BEFORE THE UNITED STATES ATOMIC ENERGY COMMISSION

In the Matter of PACIFIC GAS
AND ELECTRIC COMPANY

Docket No. 50-205

Amendment No. 7

PROPOSED FOUNDATION PLAN
 BODEGA BAY UNIT NO. 1
 To accompany Amendment No. 7
 Bodega Bay PHSR 3-27-68

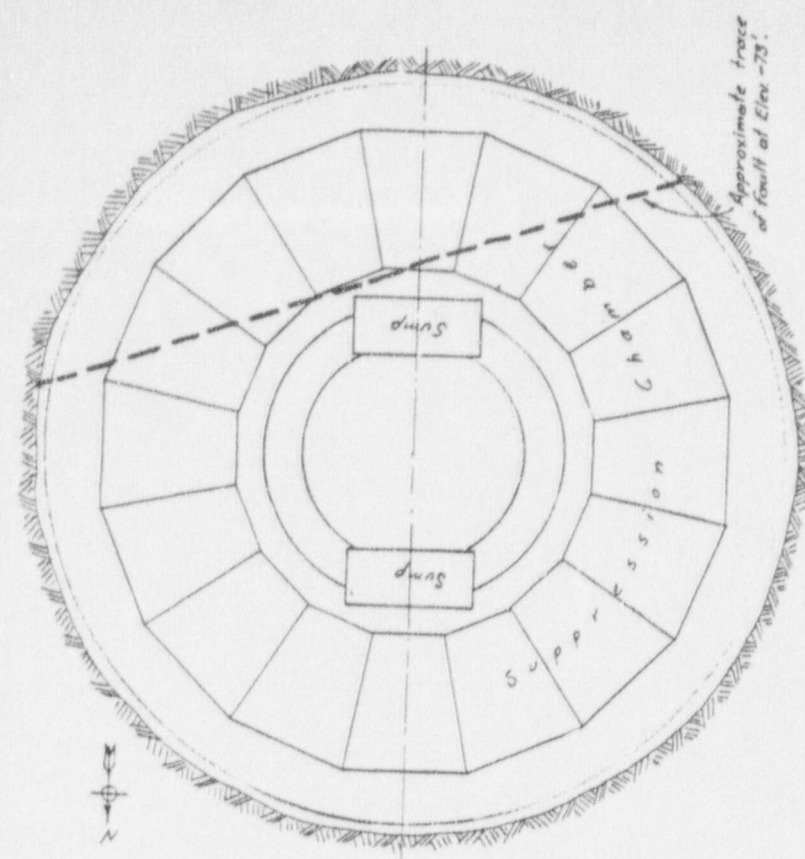
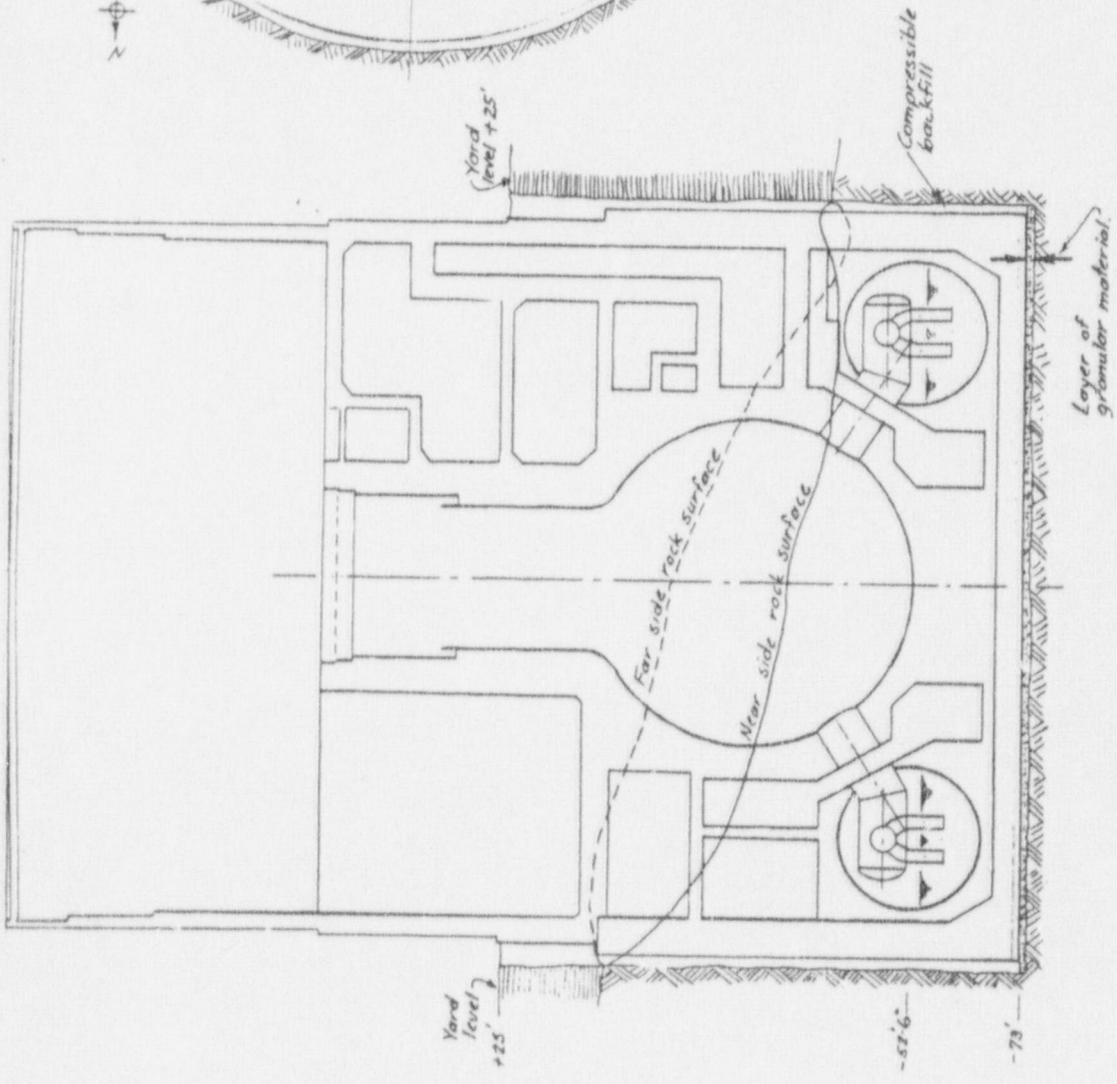
Even though the possibility of such movement occurring is not considered to be credible, the Company has developed a design concept for the Unit which will accommodate movement along this bedrock fault. As illustrated in the attached drawing, the design contemplates that the reactor containment structure will rest on a layer of granular material, such as sand, on top of the bedrock, and the space between the outside wall of the reactor containment structure and the adjacent rock will be filled with a layer of compressible material, of a type yet to be selected. This design will enable the reactor containment structure to withstand a horizontal movement along the fault of two inches without sustaining any damage or impairment of function.

In the incredible event of horizontal motion of one foot along this fault the reactor containment structure may be displaced but is not expected to suffer any damage or impairment of function, and it is expected that the Unit could be brought to a safe shutdown. With a two foot horizontal movement along this fault, the Company's analysis indicates that a part of the lower portion of the reactor containment structure may be crushed inwards up to twelve inches but the steel lining of the pressure

suppression chamber, though distorted, would remain intact. Even with this amount of motion it is expected that there would be no impairment of containment and that the Unit could be brought to a safe shutdown.

Vertical movements up to two feet are not expected to damage the reactor containment structure nor impair its function but might result in the structure being tilted slightly.
